**VIRGINIA ELECTRIC AND POWER COMPANY (DOMINION)**  
**NORTH ANNA POWER STATION UNITS 1 AND 2**  
**EDITORIAL CORRECTION FOR**  
**PROPOSED TECHNICAL SPECIFICATIONS CHANGE REQUEST**  
**REACTOR COOLANT SYSTEM PRESSURE/TEMPERATURE LIMITS**  
**LTOPS SETPOINTS AND LTOPS ENABLE TEMPERATURES**

**Attachment  
(Serial No. 04-380B)  
Virginia Electric and Power Company  
North Anna Power Station Units 1 and 2**

**Corrected Marked-up and Proposed Technical Specification Pages  
Proposed Technical Specification Changes for  
Reactor Coolant System Pressure/Temperature Limits  
LTOPS Setpoints and LTOPS Enable Temperatures**

Figure 3.4.3-2 (page 1 of 1)  
North Anna Units 1 and 2 Reactor Coolant System Cooldown Limitations  
(Cooldown Rates up to 100°F/hr),  
Applicable for the first 50.3 EFPY for Unit 1, and 52.3 EFPY for Unit 2  
(Including Margins for Instrumentation Errors)

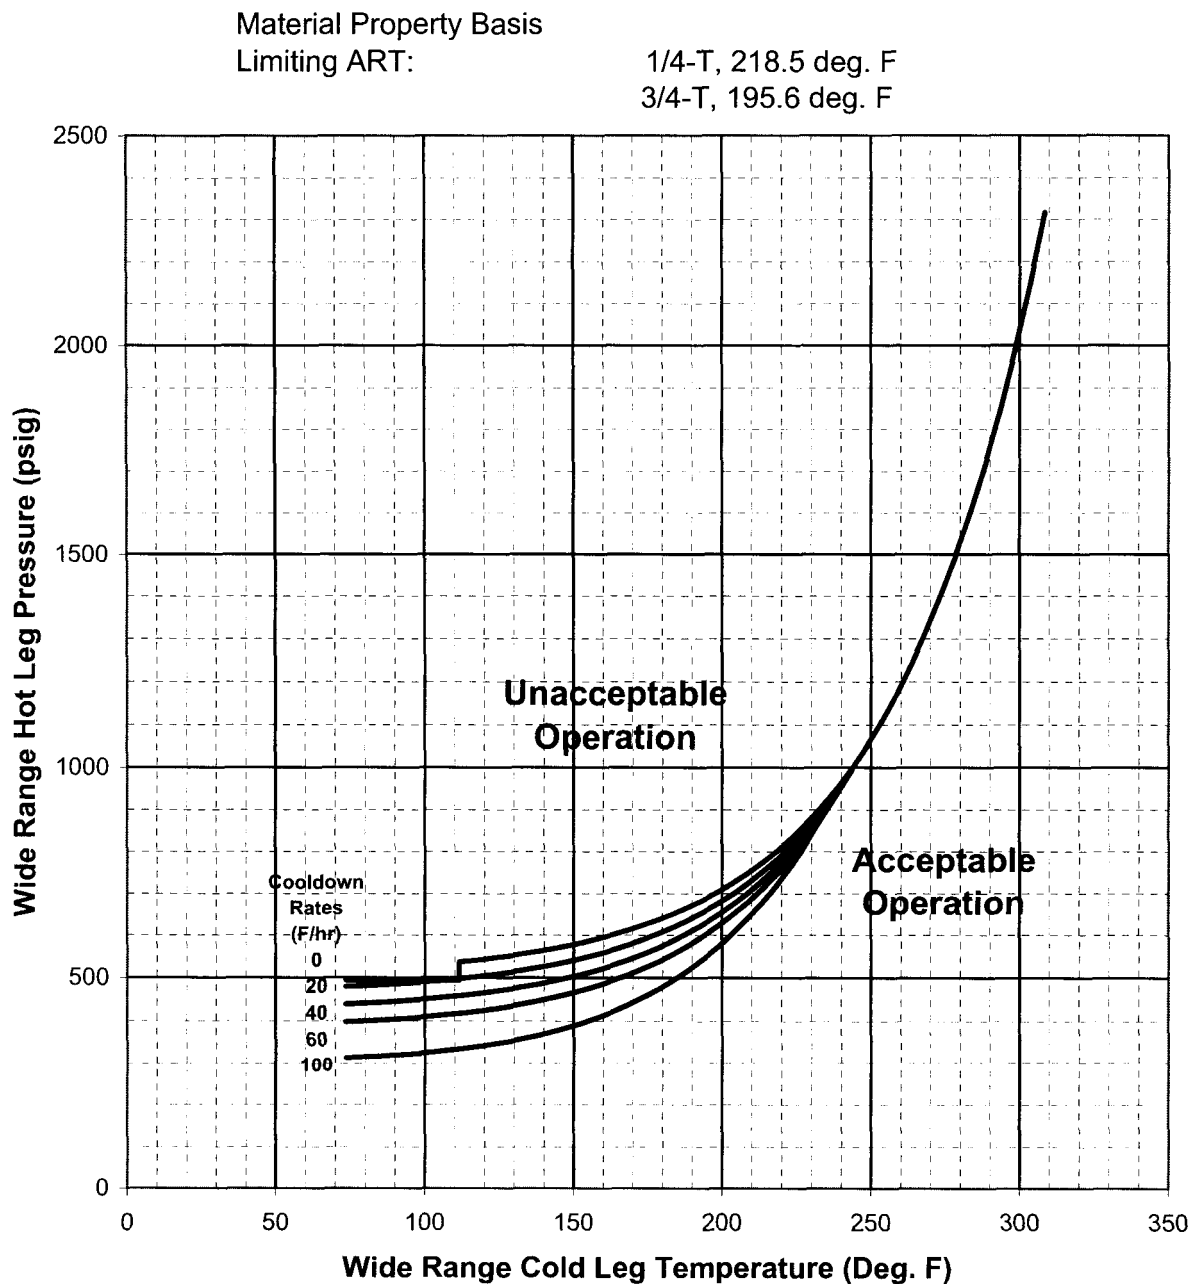
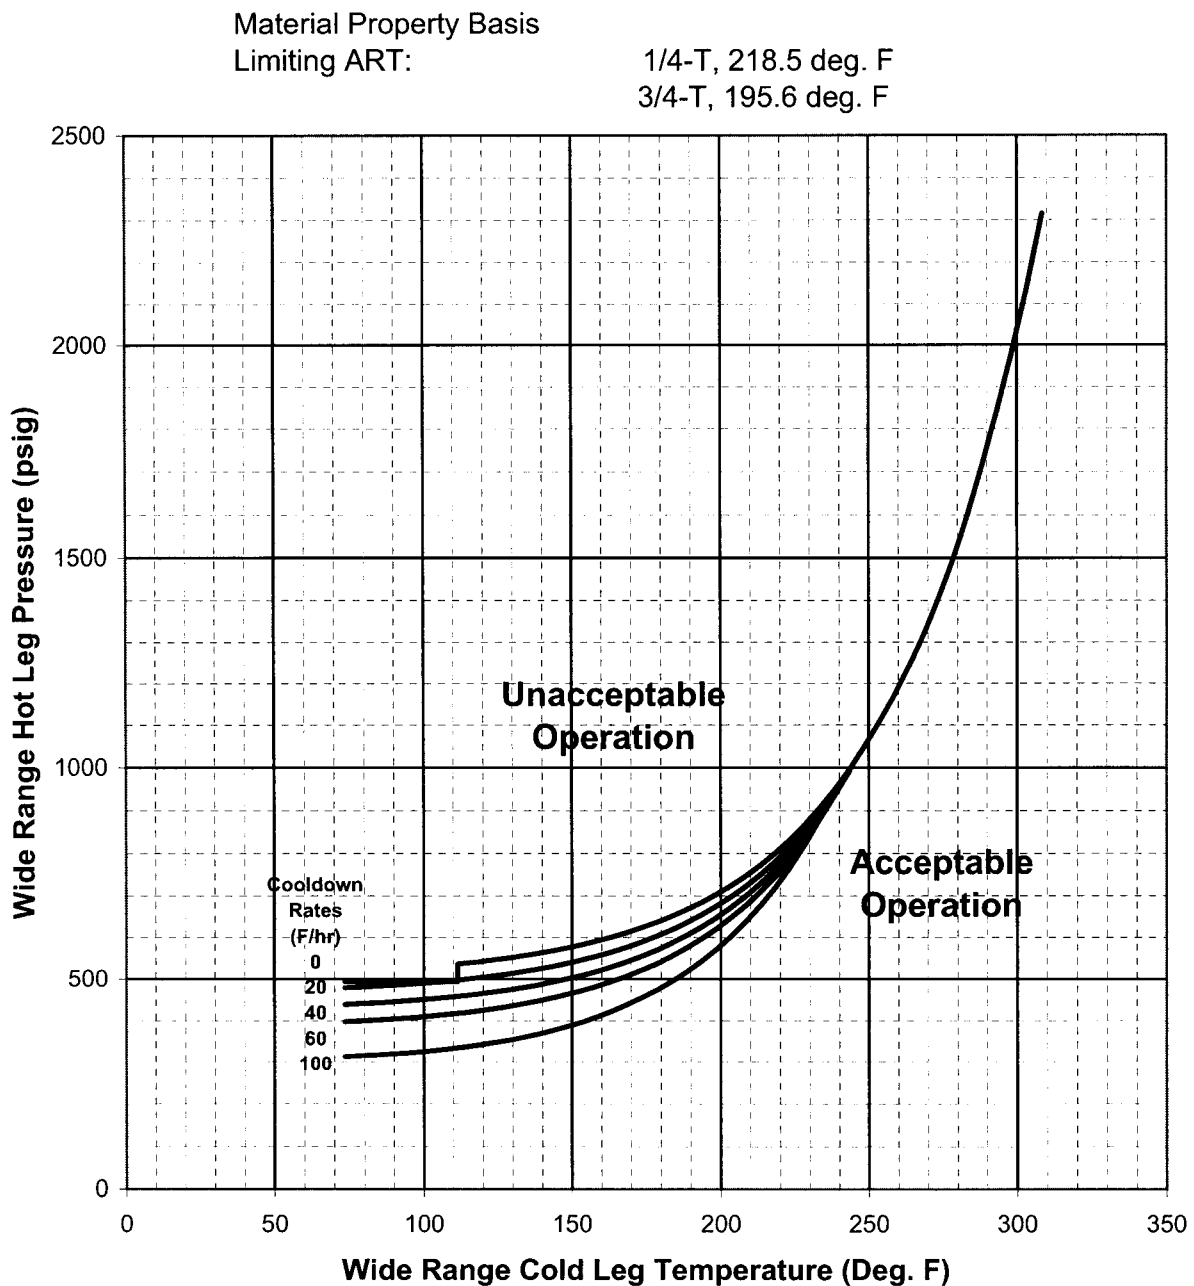
In a letter dated July 1, 2004 (Serial No. 04-380), Dominion requested an amendment to Facility Operating License Numbers NPF-4 and NPF-7 in the form of changes to the Technical Specifications for North Anna Power Station Units 1 and 2. The proposed changes will provide Reactor Coolant System (RCS) pressure/temperature (P/T) operating limits, Low Temperature Overpressure Protection System (LTOPS) setpoint allowable values, and LTOPS enable temperature ( $T_{enable}$ ) values to cumulative core burnups up to 50.3 Effective Full Power Years (EFPY) and 52.3 EFPY, which correspond to the period of the renewed license, for Units 1 and 2, respectively. During a recent review of the proposed technical specification change, a typographical error was identified in the proposed Technical Specification package. Specifically, the cooldown rate was incorrect in the title of Figure 3.4.4-2. The corrected marked-up and proposed pages are provided in the attachment to this letter.
